Recommendations:

Typical Application Circuit

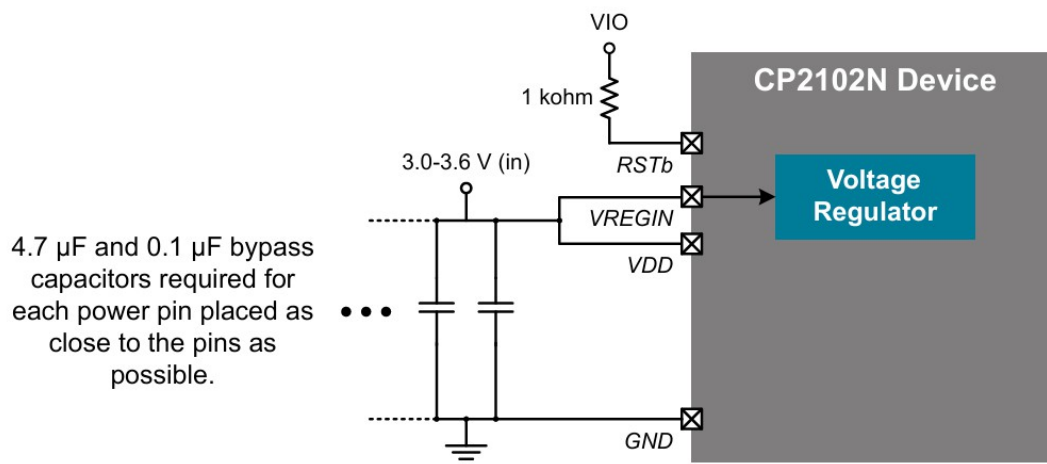
- The connection of the battery charger U2 is incorrect. With the current configuration, the Vbus voltage from the USB (+5V_USB) is being routed to both the input and the output of the charger, which is not correct. Essentially, the input and output of the charger are short-circuited. The Vbus voltage from the USB should only be connected to the input of the charger and not to its output. The circuit should be powered from the output of the charger U1. Therefore, changes need to be made to the wiring of the Voltage Regulator U2 so that it is powered by the output of the charger. The correct connection of the charger is shown in the diagram below:

1. Correction of the U1 connection.
2. Correction of the U2 connection.
3. Addition of 100nF capacitors in parallel with the 10uF capacitors at the input and output of the voltage regulator.

Figure 2. MAX4466 Typical Application Circuit

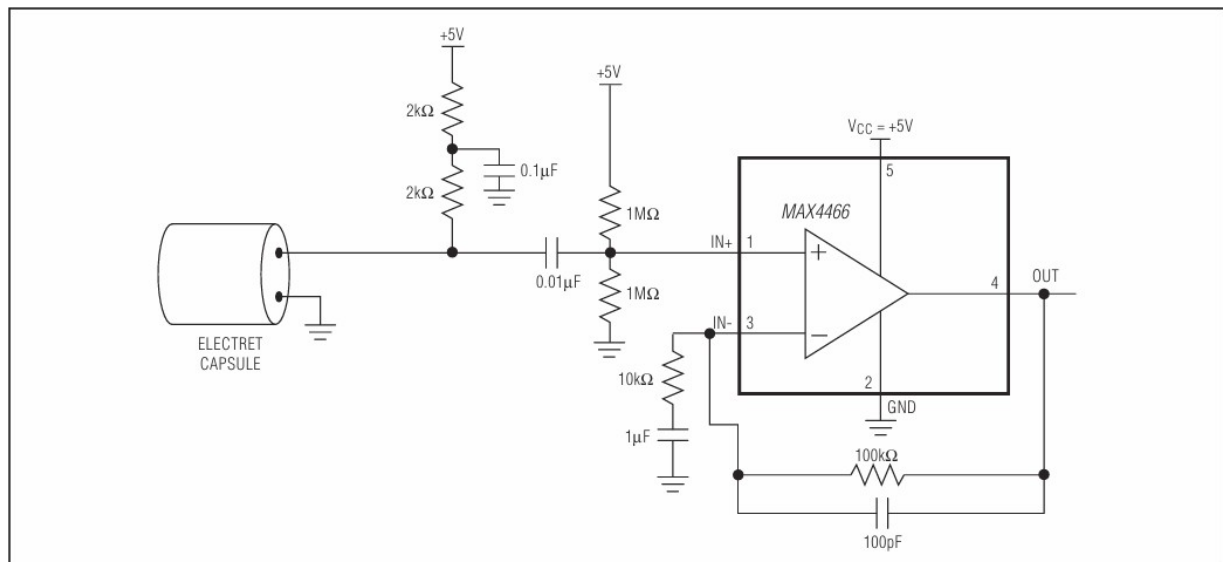
- VCC pin of U7 (MAX4466EXK) is connected to 3.3V through a resistor R33 2K2. R33 must be removed and the VCC pin should be connected directly to 3.3V
- The connection of the Microphone Preamplifier U7 (MAX4466EXK) is incorrect. The following wiring, as recommended by the manufacturer, is suggested for operation with an ELECTRET CONDENSER MICROPHONE.

23. Removal of C16.
24. Removal of R33. Connection of VCC directly to 3.3V.
25. Redesign of the pre-amplifier U4.
26. Removal of resistor R22.
27. Removal of resistor R29.
28. Adding a pull-up resistor to the CD pin of the SD card.
